May 27, 2025

**Appeal of Planning Commission Decision Approving Removal of 3 Protected Native Oak Trees
CDTP24-00064
19 Jay Court, Alamo, CA**

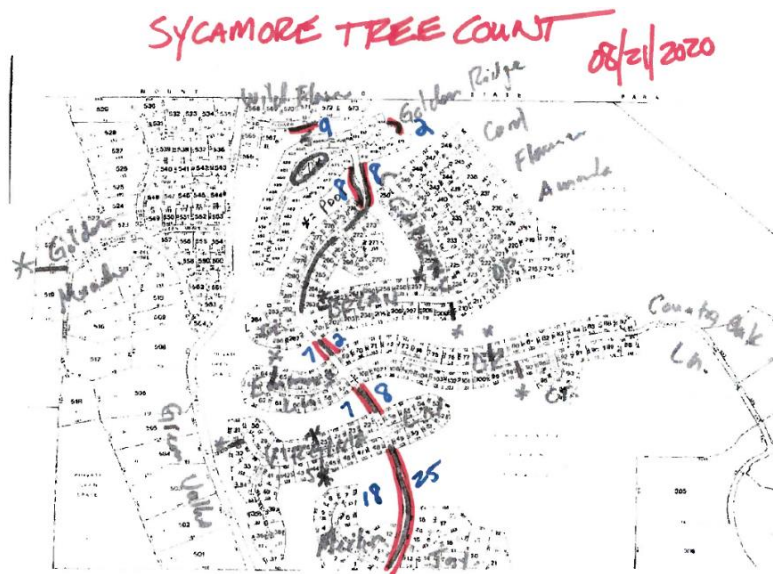
Items a) through e) have been addressed elsewhere; however, item f) and g) are further explained below.

Item F:

The hillside slope is currently maintained and landscaped as open space with the planting of a continuous row of 25 Sycamore trees and open grass hillside continuously along Stone Valley Road and continuing unabated to the next privately owned property at Virginia Lane. This use is consistent with all other HOA owned open space areas along Stone Valley Road (*See Video email to Nai Stephens*). All other privately owned backyard or side yard sloped areas fronting Stone Valley Road are planted and maintained by the homeowner.

Upon entering Bryan Ranch, neighbors are used to driving past open space lined with beautiful Sycamore trees. The proposal at issue will introduce a disjointed fence surround and solar structure that is not in alignment with any other fences in the community and permanently alter the look and feel of Bryan Ranch.
